# SERVICE BULLETIN SPSB009

SUBJECT: SUPPLIER/VENDOR RECALL OF PS70104 HOUSINGS (METAL FLEX HOISING INC)

STATUS: MANDATORY INSPECTION AND REPLACEMENT OF RECALLED HOUSINGS

**WEARERS LEFT SIDE:**

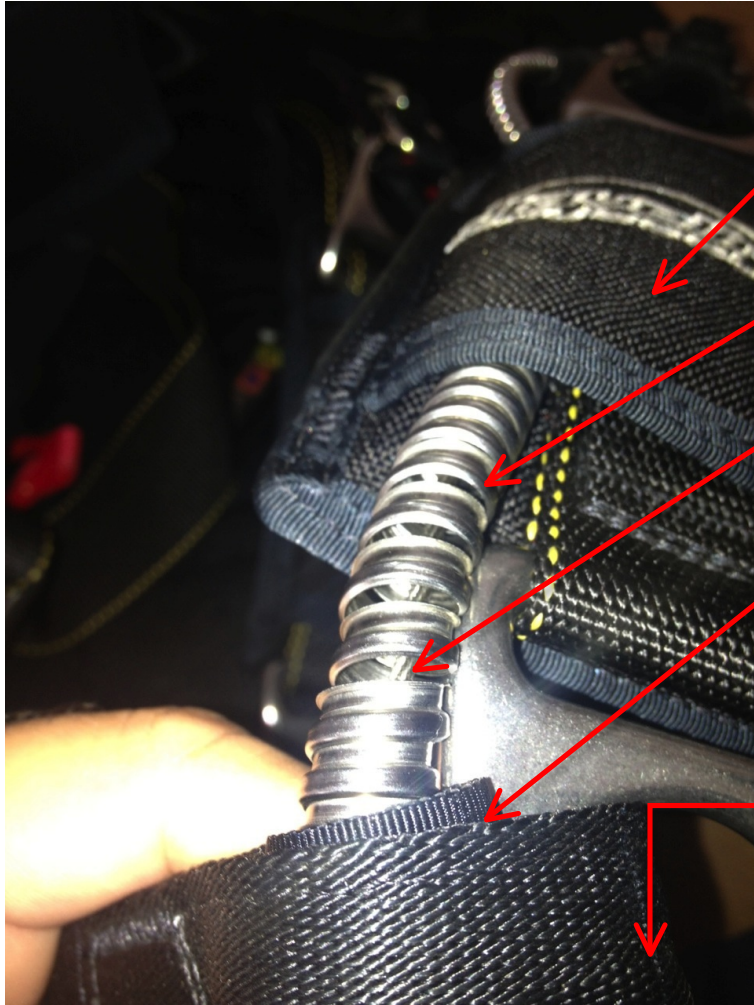
**What to inspect:** All JA101-XX harness container systems listed in table above. Inspect Reserve Ripcord housing.

If the serial number is listed in the above table, inspect the available exposed reserve ripcord housing. Locate the lower end of the housing, which is clamped to the Main Lift Web, just above the reserve ripcord pocket. Inspect the exposed length of housing from the clamp upwards; ensure that the coil has not separated/unraveled. Be sure to inspect the section that is routed through the chest strap.

A. HOUSING FOUND TO BE INTACT (GOOD): The rig may continue to be jumped with periodic monitoring until the next repack cycle or earlier elective replacement. However this housing must be replaced at the next repack cycle. See <http://www.sunpath.com/support/HousingReplacement.pdf> for instructions for your rigger to complete the replacement of the housing.

B. HOUSING FOUND TO BE SEPERATED/UNRAVELLED (BAD): The housing must be replaced before the next jump by a certificated senior or master parachute rigger (or foreign equal) or the manufacturer. See <http://www.sunpath.com/support/HousingReplacement.pdf> for instructions for your rigger to complete the replacement of the housing or instructions to send your system back to the manufacturer.
